STERLING RANCH FILING NO.2

GRADING & EROSION CONTROL PLAN

JOB NO. 25188.01

SHEET 2 OF 8

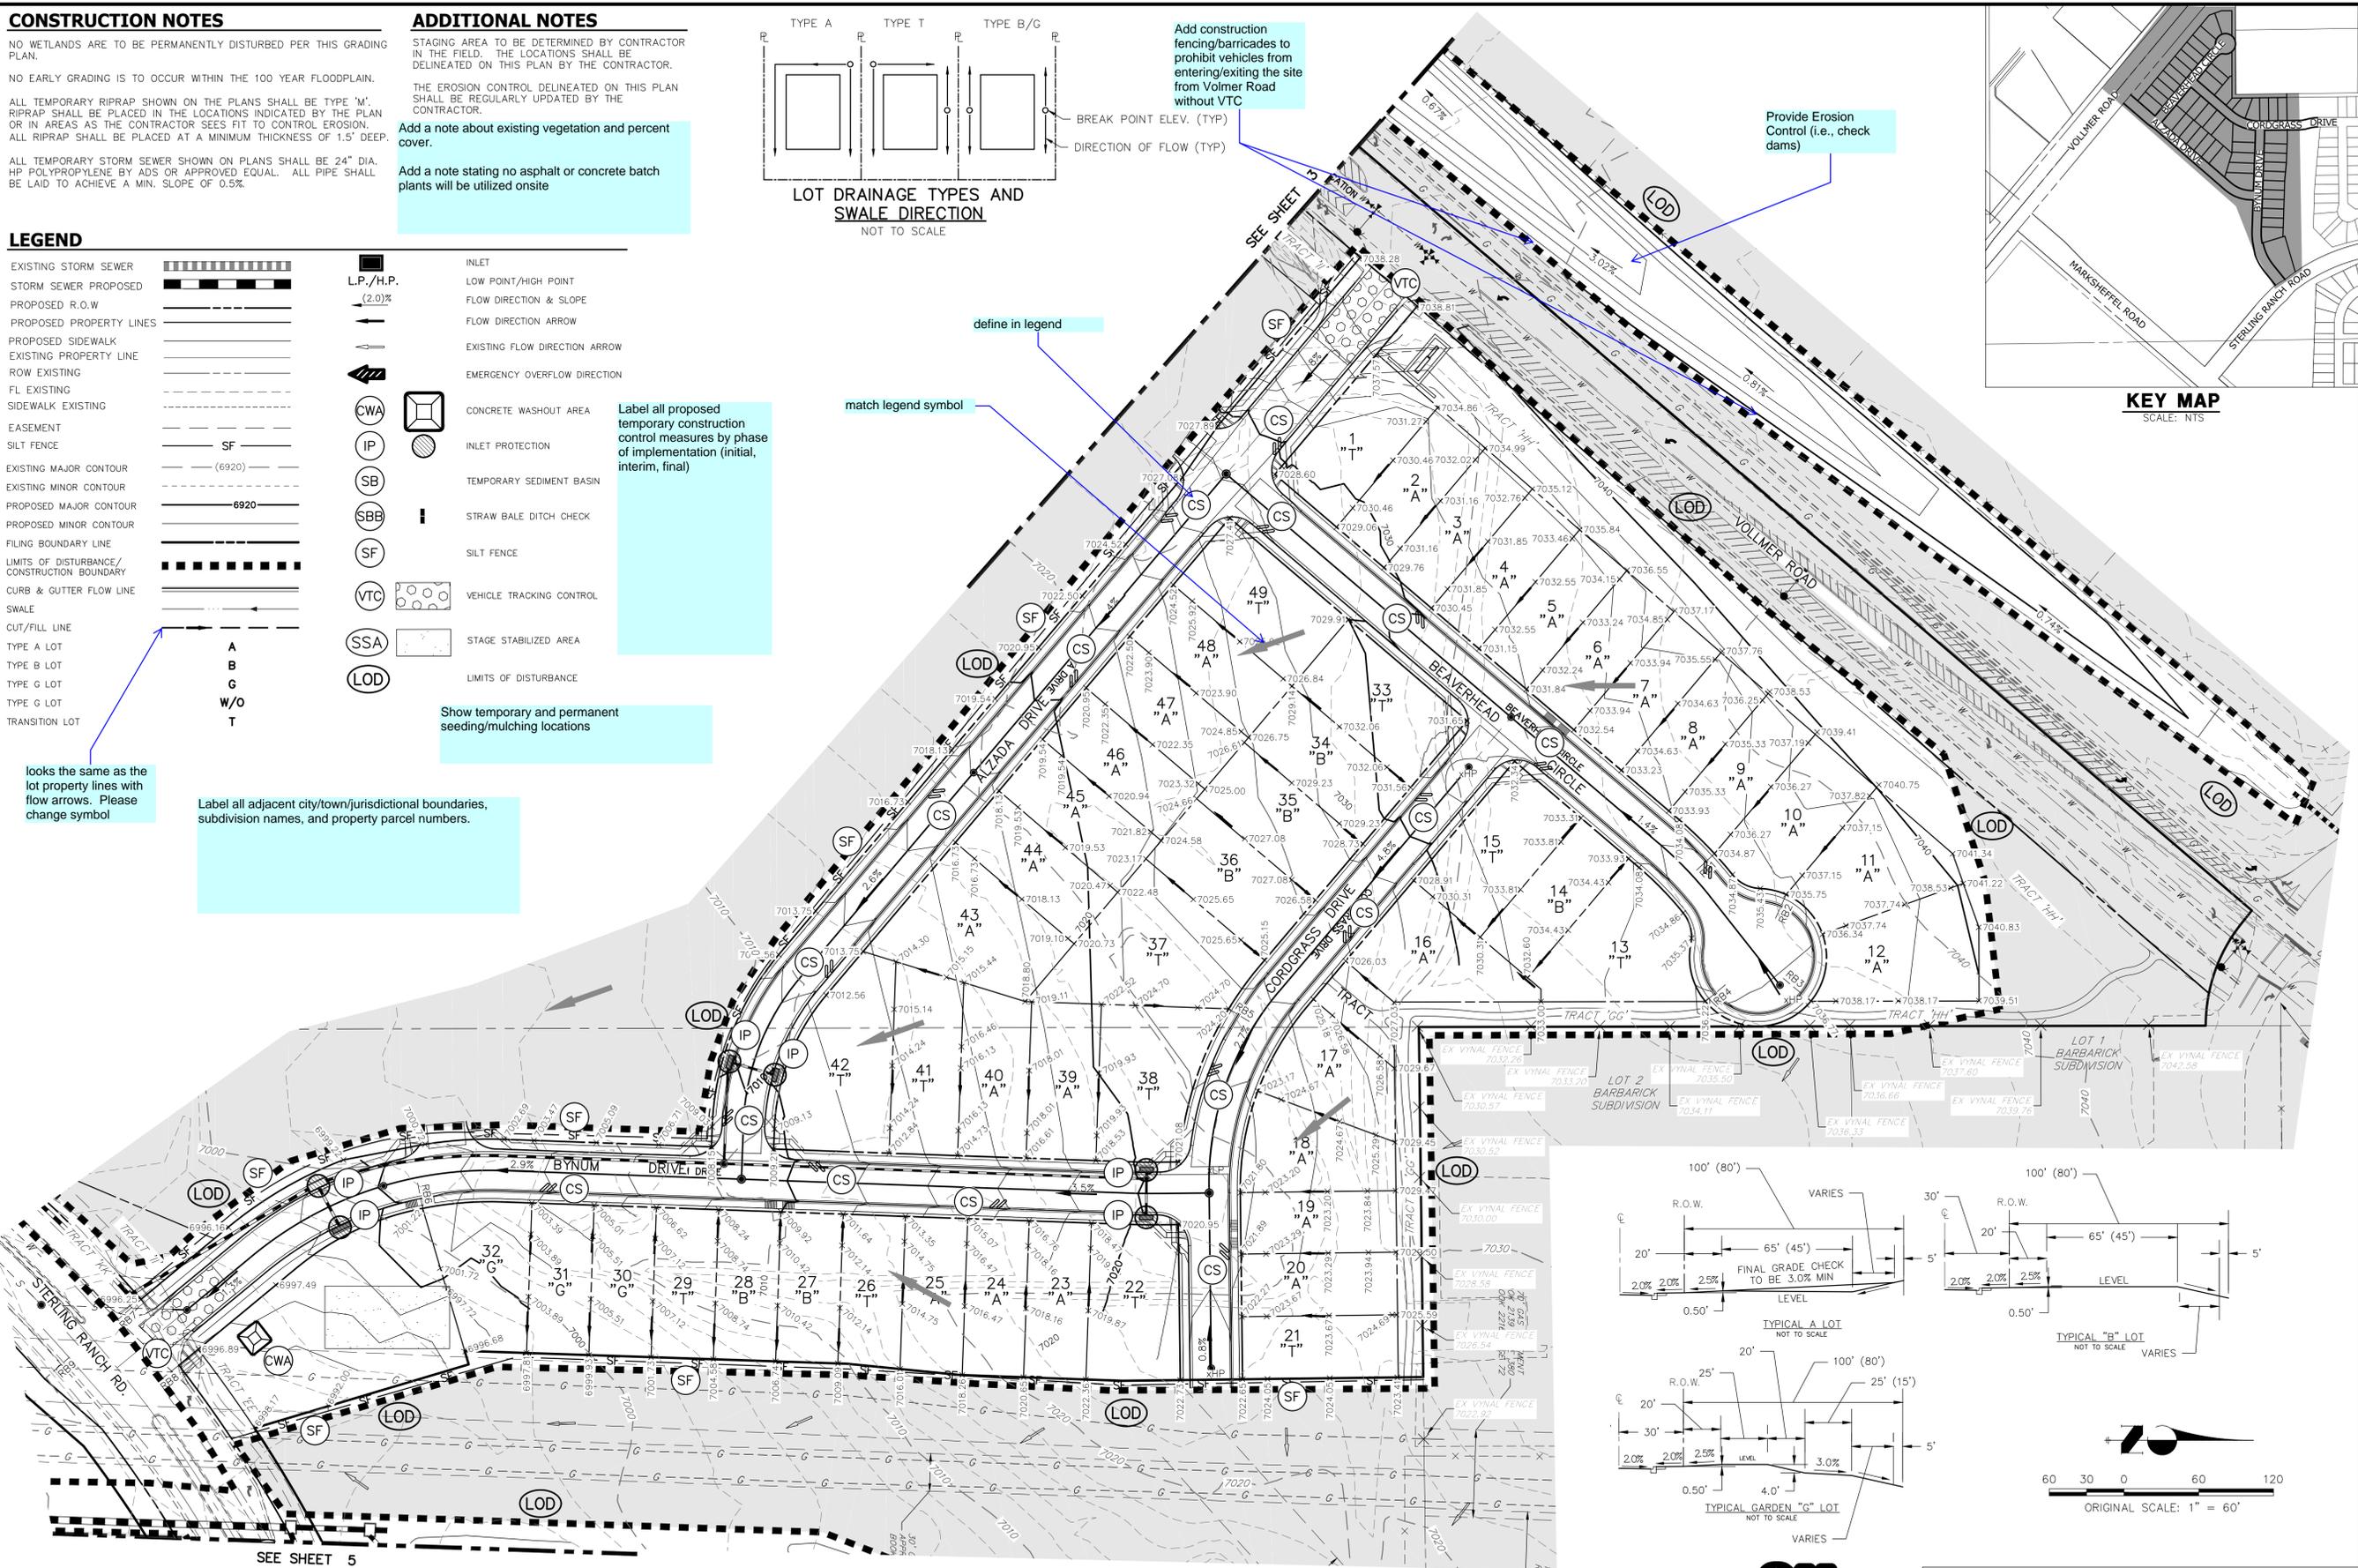
Add a note about existing vegetation and percent cover.

Add a note stating no asphalt or concrete batch plants will be utilized onsite

Add construction fencing/barricades to prohibit vehicles from entering/exiting the site from Volmer Road without VTC

Provide Erosion Control (i.e., check dams)

Label all proposed temporary construction control measures by phase of implementation (initial, interim, final)

Show temporary and permanent seeding/mulching locations

Label all adjacent city/town/jurisdictional boundaries, subdivision names, and property parcel numbers.

looks the same as the lot property lines with flow arrows. Please change symbol

match legend symbol

define in legend

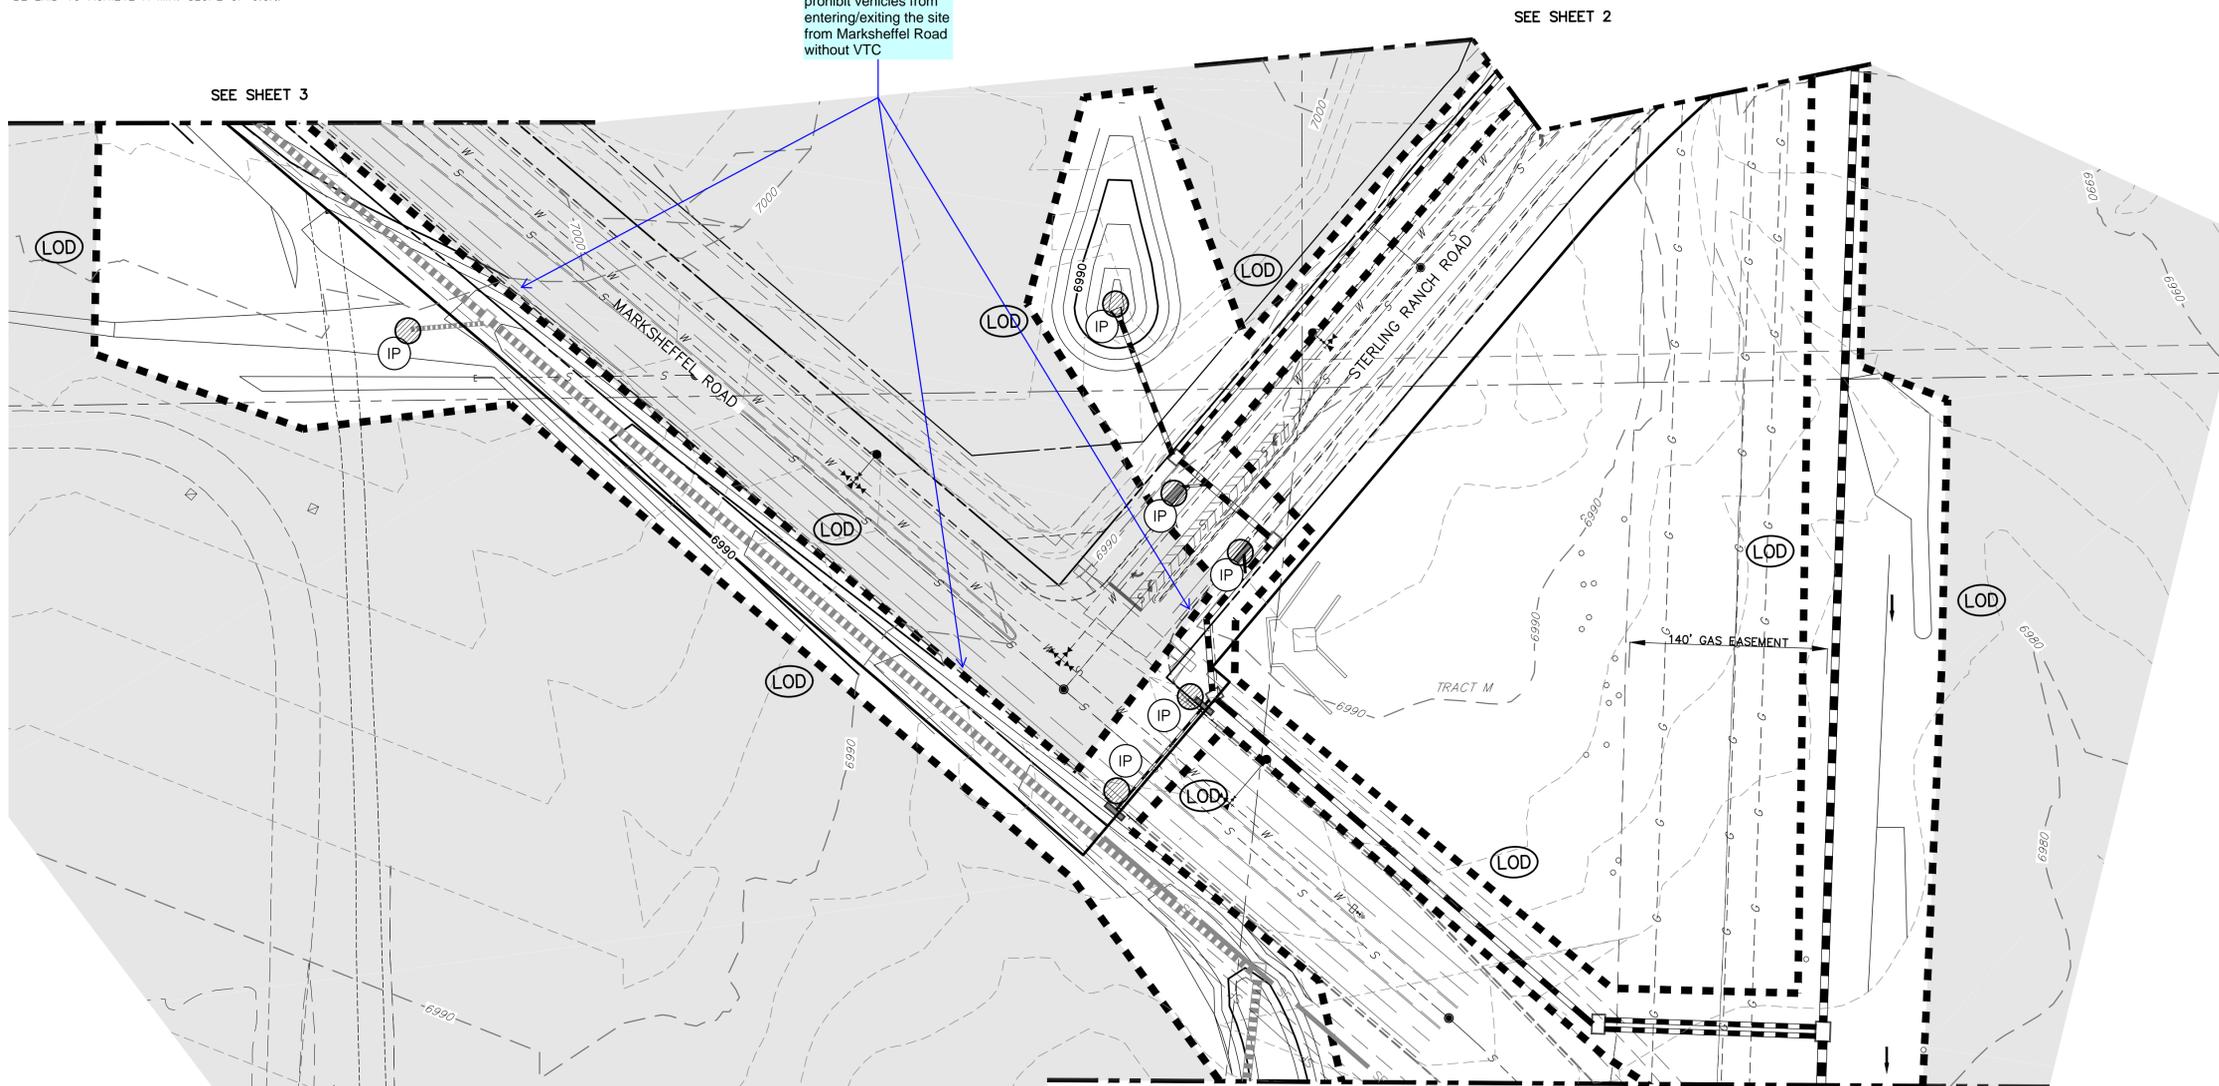
Add construction fencing/barricades to prohibit vehicles from entering/exiting the site from Marksheffel Road without VTC
